NINE MILE POINT NUCLEAR STATION, UNIT NO. 1

AMENDMENT TO FACILITY OPERATING LICENSE

Amendment No. 81  
License No. DPR-63

ATTACHMENT TO LICENSE AMENDMENT NO. 81

Figure 3.1.7f Maximum Allowable Average Planar LHGR Applicable to P8DRB299 and Future Reload Fuel as described in Reference 8.

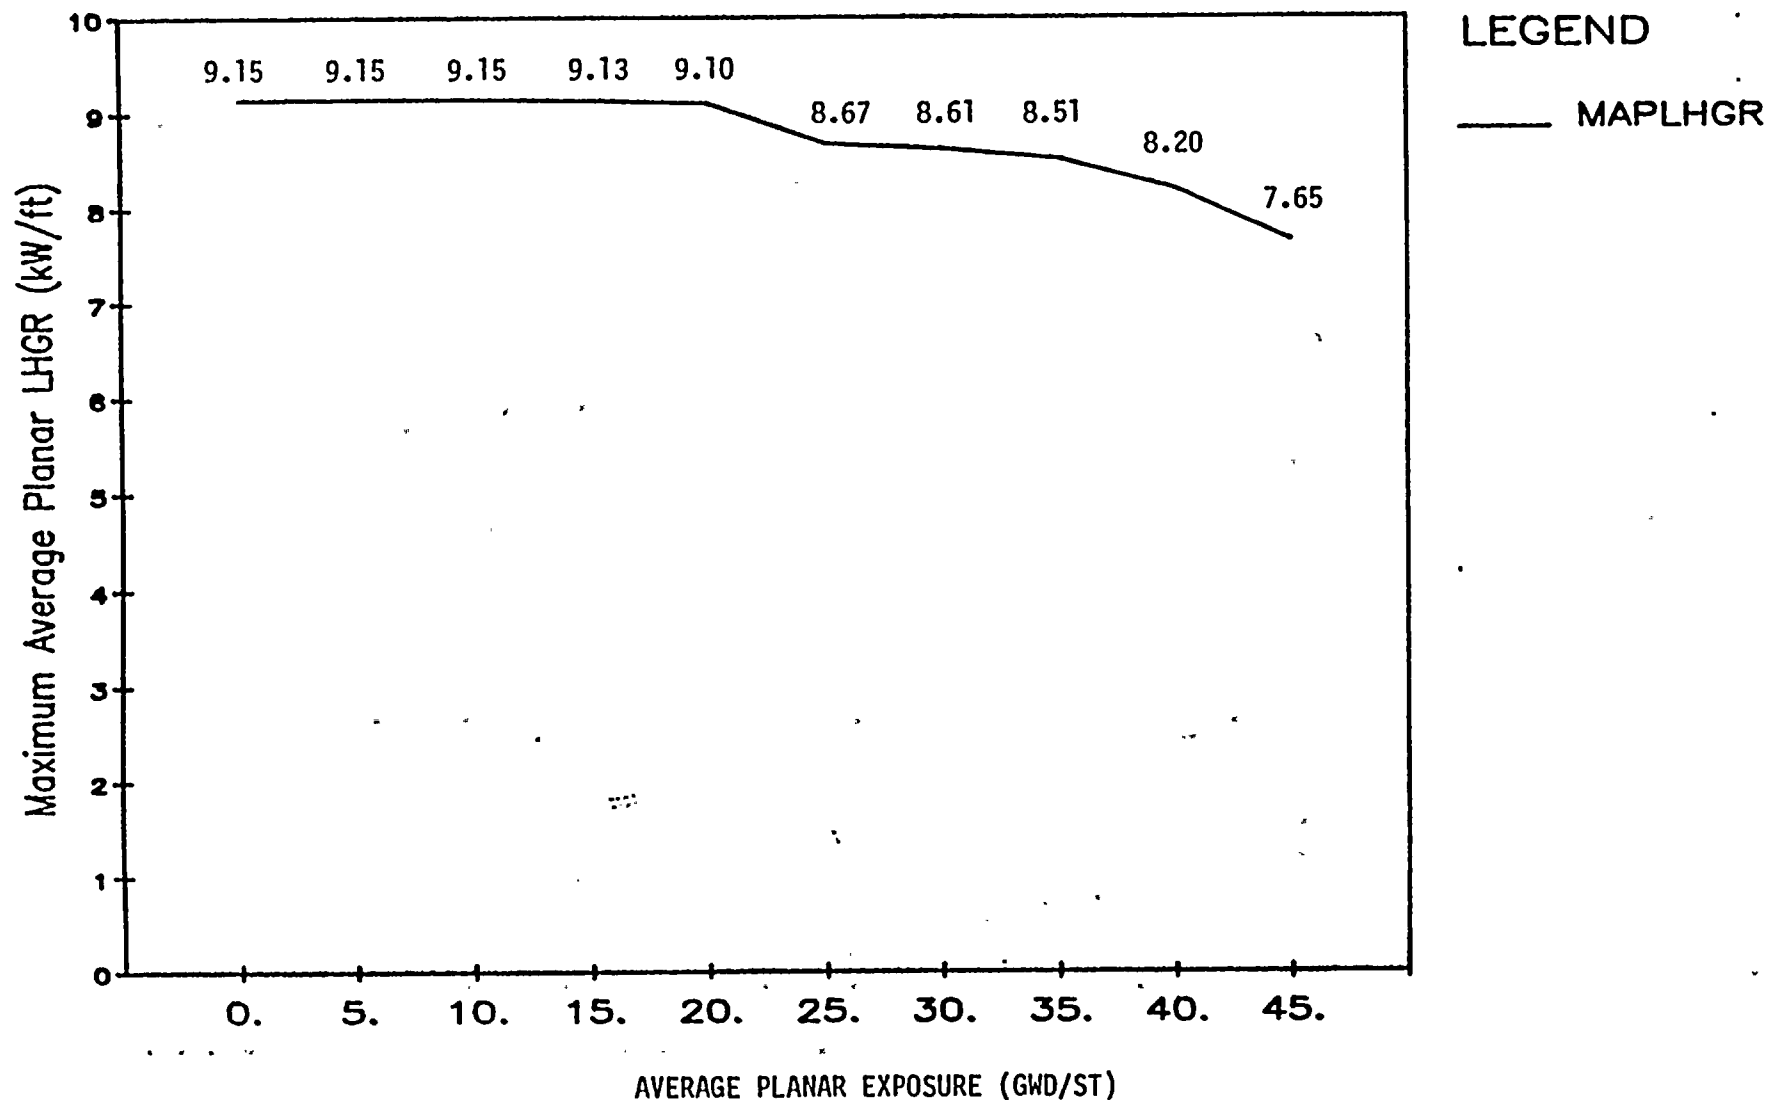
During power operation, the APLHGR for each type of fuel as a function of average planar exposure shall not exceed the limiting value shown in Figures 3.1.7a, 3.1.7b, 3.1.7c, 3.1.7d, 3.1.7e and 3.1.7f. If at any time during power operation it is determined by normal surveillance that the limiting value for APLHGR is being exceeded at any node in the core, action shall be initiated within 15 minutes to restore operation to within the prescribed limits. If the APLHGR at all nodes in the core is not returned to within the prescribed limits within two (2) hours, reactor power reductions shall be initiated at a rate not less than 10% per hour until APLHGR at all nodes is within the prescribed limits.
